# Access Compliance Report

## Public Rights-of-Way

### (Curb Ramps)

Intersection ID: 10806	Main Street: MORSON_ST	Cross Street: STATE_ST	Location: SW
ADA ID: 8E3288701D87	Ramp Type: Directional2	Initial Pass/Fail: Fail	Overall Compliance: No
Severity Score: 21.25			
Codes/Mitigation Info/Possible Solution		Field Measurements/Component Compliance

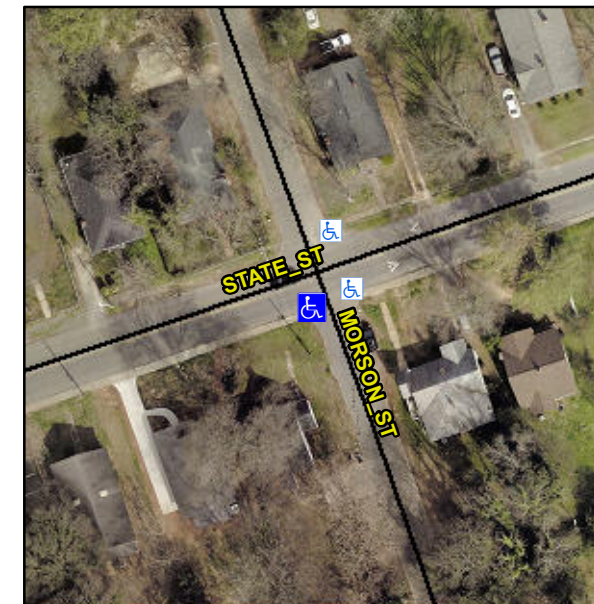
**NO CURB**

**R304.5.1, R304.2.2**

**Remove & Replace Entire Ramp.**
